Potomac Yard Design Advisory Committee Meeting (PYDAC)

April 22, 2015

DATE: April 16, 2015
TO: Potomac Yard Design Advisory Committee
FROM: Planning Staff
SUBJECT: Landbay G, Block A – National Industries for the Blind

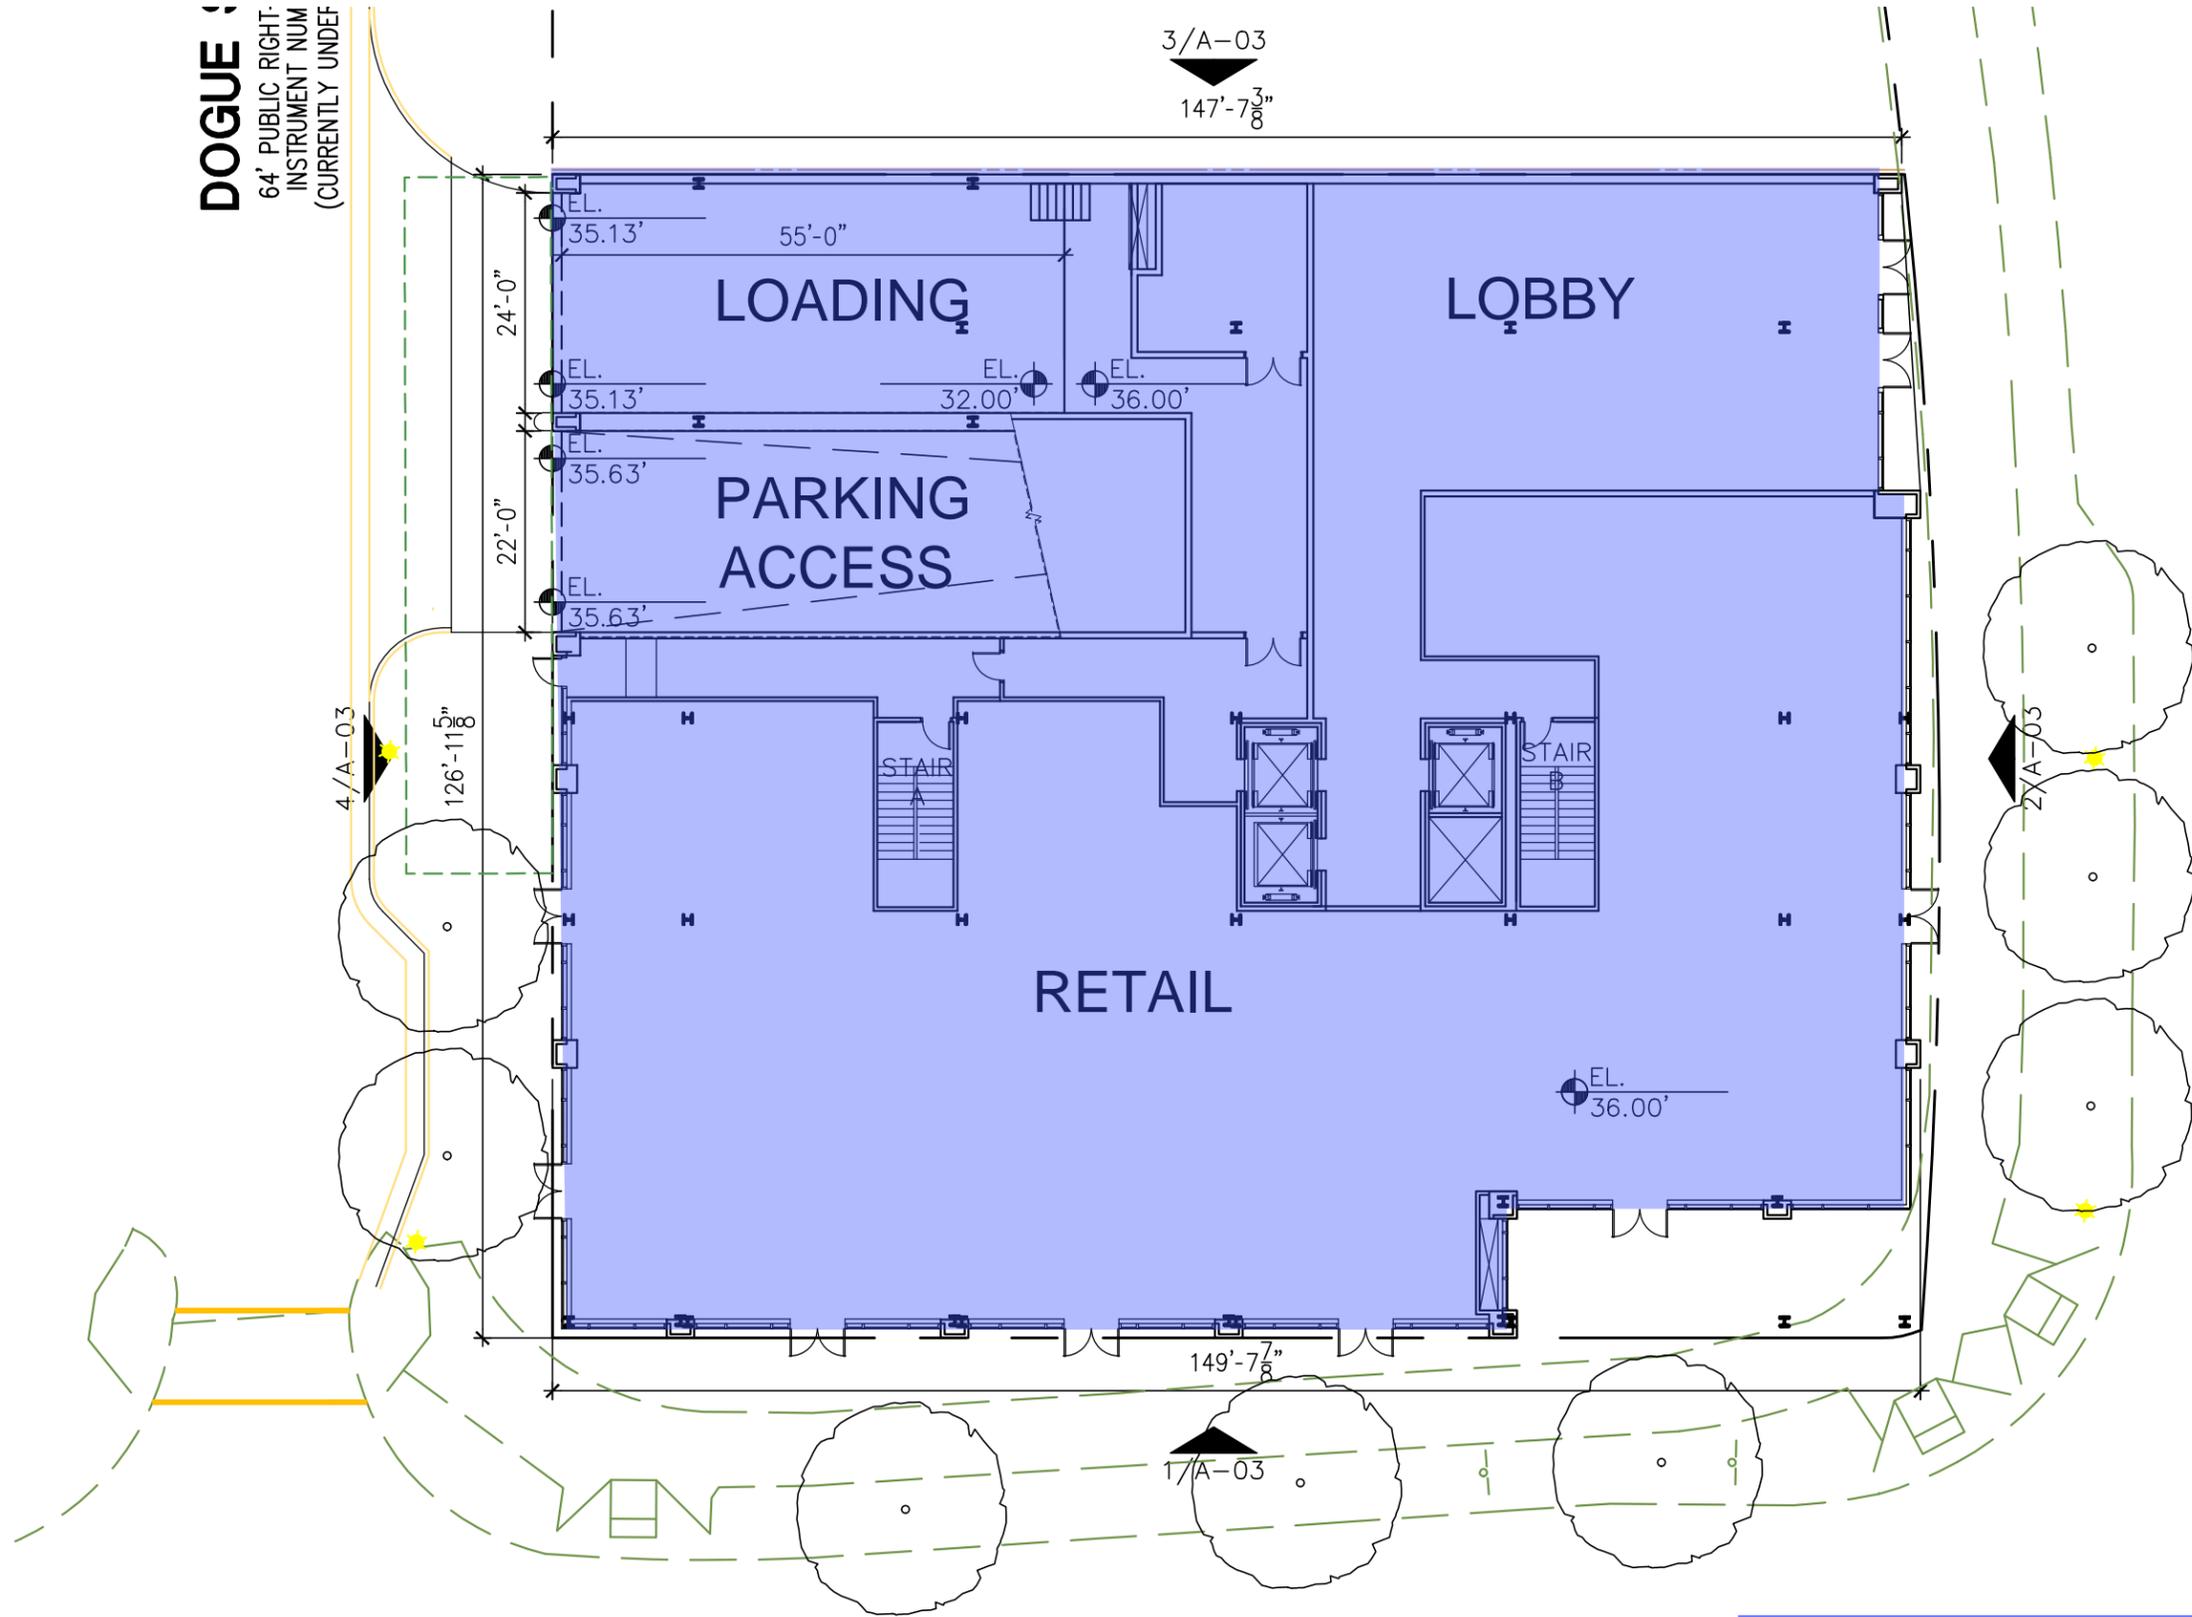
The East Glebe Road frontage of Block A was identified as a preferred retail location in the Coordinated Development District Amendments approved in November, 2010 due to the site's proximity to the Town Center Green. As previously noted, the applicant proposes to construct retail consistent with the Coordinated Development District.

Preliminary Ground Floor Plan

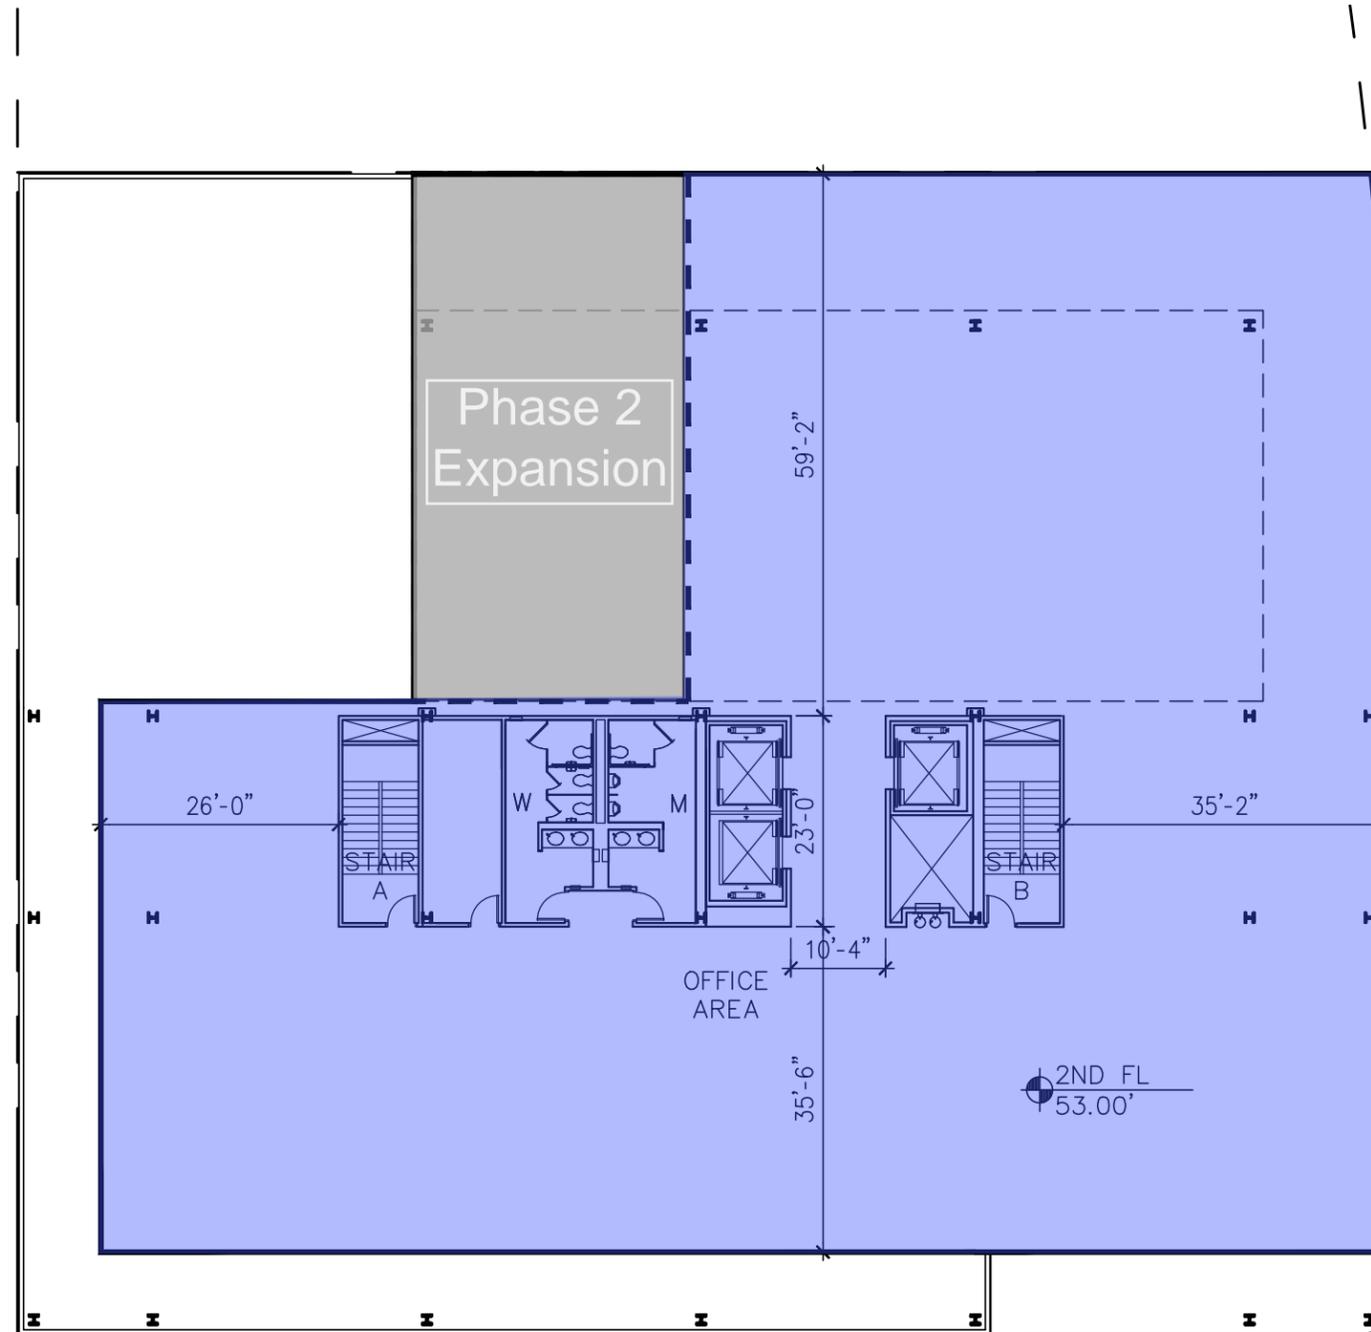
- Staff is considering the impacts of the construction of only half of the block, and has requested additional information from both the applicant and the property owner of Parcel A1 to demonstrate how a second building could be accommodated on the remaining parcel in the future. Staff has also requested that the applicant explore providing a connection within the garage to achieve a single loading and parking entrance for both buildings in the future.

- Staff is also concerned that Dogue Street will ultimately have multiple garage doors and loading docks to serve the separate buildings, rather than a combined service area.

- The applicant proposes a subdivision of Block A, which divides the block into two nearly equal parcels. As proposed, the NIB building program does not appear to require half of the block. Staff may recommend that the applicant study opportunities to shift the proposed property line south to accommodate the NIB building while maximizing the development potential of the northern parcel.
